June 11, 2015

Our File: 112-3155

**Re: Proposed "The George" Mixed Use Development  
377, 385 & 407 Gower Point Road, 397 & 689 Winn Road, and Winn Road Right-of-Way,  
Gibsons, BC  
Memorandum Regarding Geotechnical Review Report**

FIGURE  
**1** OF 1

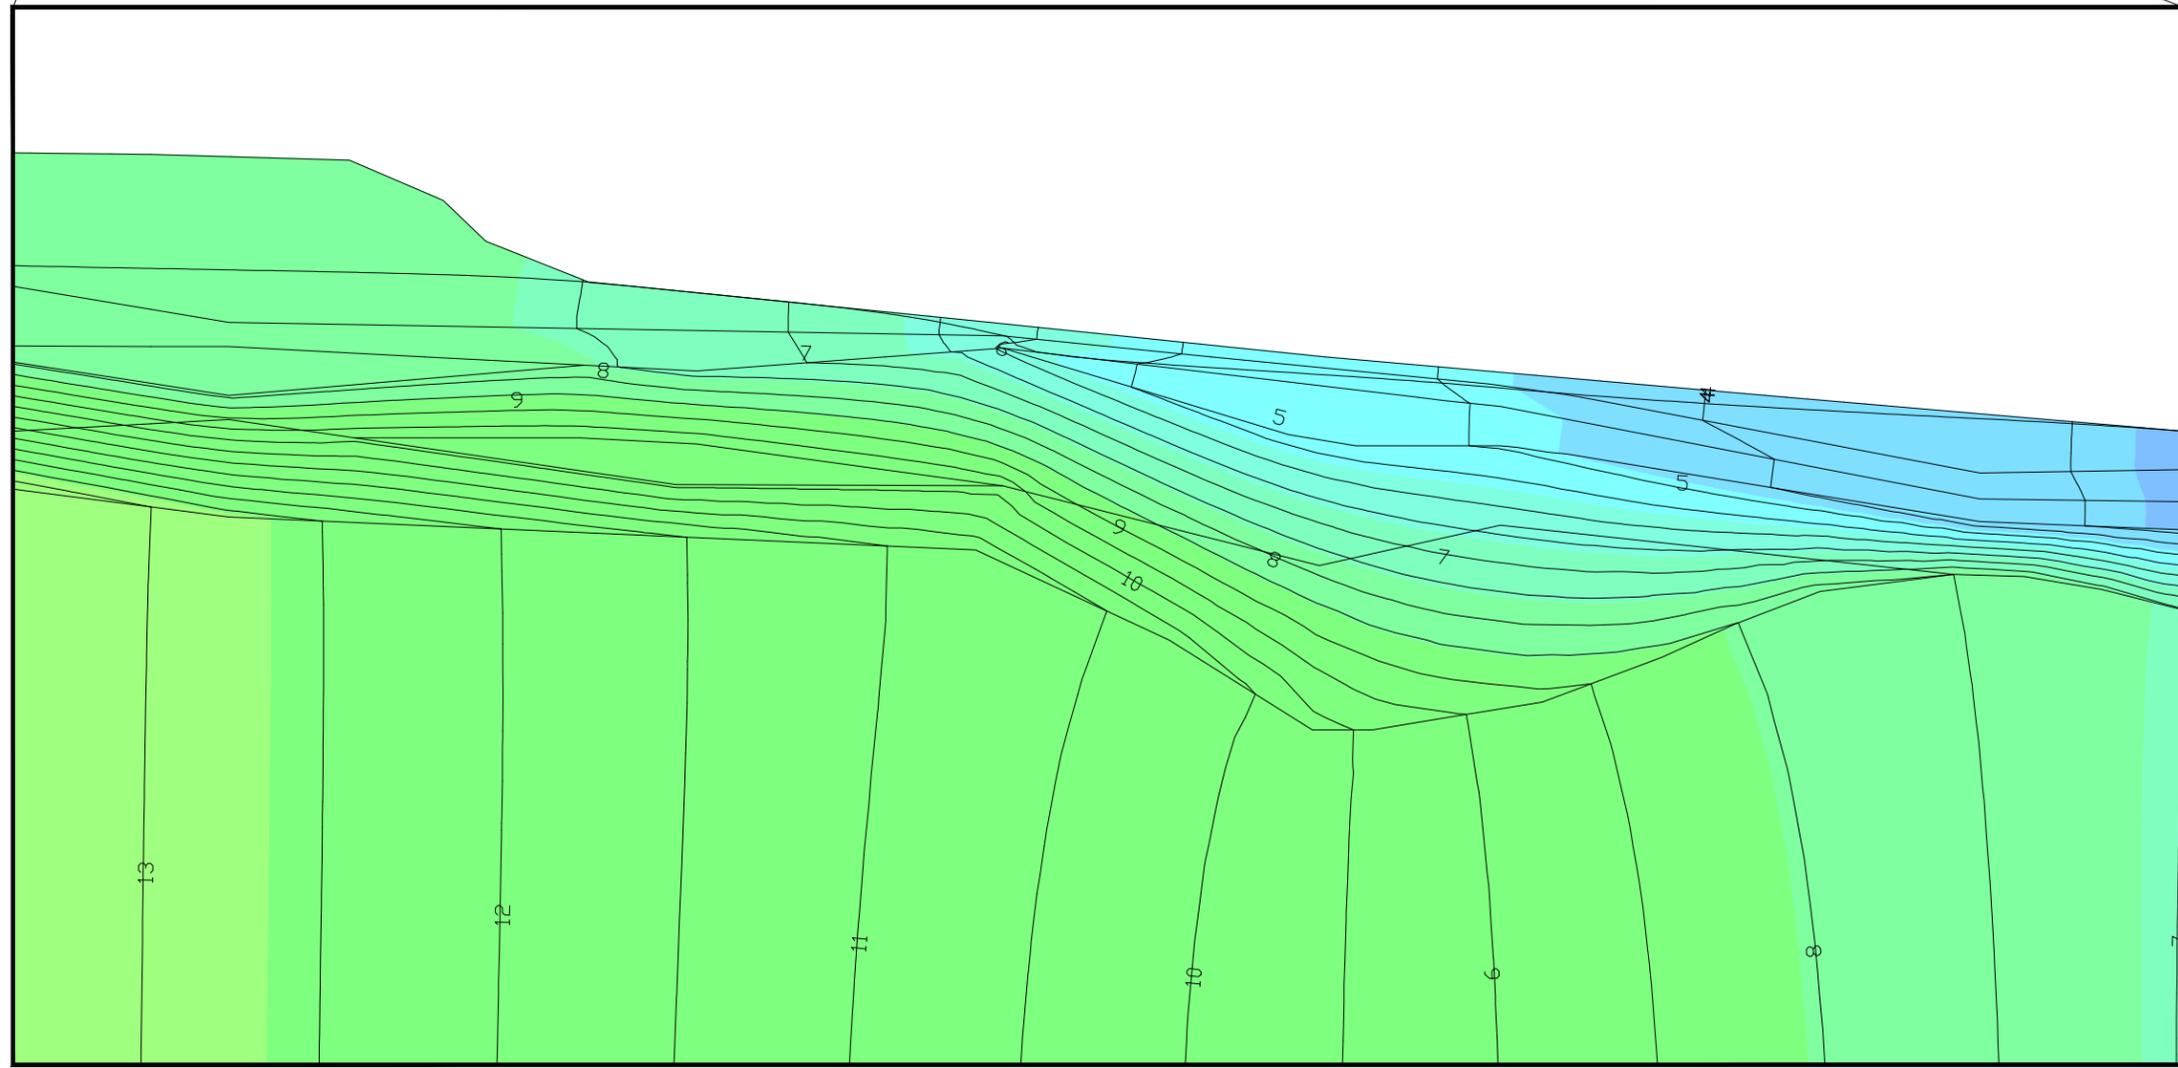
### Section 2.0 - Discussion, Paragraph 5

Vertical hydraulic gradients were considered during the computer modelling work that is described in Section 8.0 of our report. Upward artesian water pressures within the Gibsons Aquifer were analyzed in order to estimate changes in subsurface stress conditions as excavation progresses and to determine the magnitudes of potential ground movements at each stage. This modelling work has been revisited since the April 7, 2015 report was issued, as discussed in our memorandum regarding the hydrogeological review report. For information, a print out of the calculated upward hydraulic gradient where the excavation for the P2 parking level is proposed is attached to this document.

As we show in our report, as supported by extensive computer modelling, the excavation for the proposed building will mainly be limited to removal of some of the fill materials that were placed relatively recently for the construction of Gower Point Road. If these fill materials were not present,

the proposed development would not excavate into the natural ground (except at limited areas that removal of minor thicknesses of peat, sand, and silty sand materials are also proposed) and there would be no significant / major stress change in the ground below (including within the Gibsons Aquifer). One of the reasons that the computer modelling carried out for this project is judged to be a conservative approach is that we did not simulate the previous natural, stable condition prior to the placement of fill materials. If that would have been carried out, the net stress change at depth would be near zero (comparing to the original / natural in-situ stresses) due to construction of the proposed building.
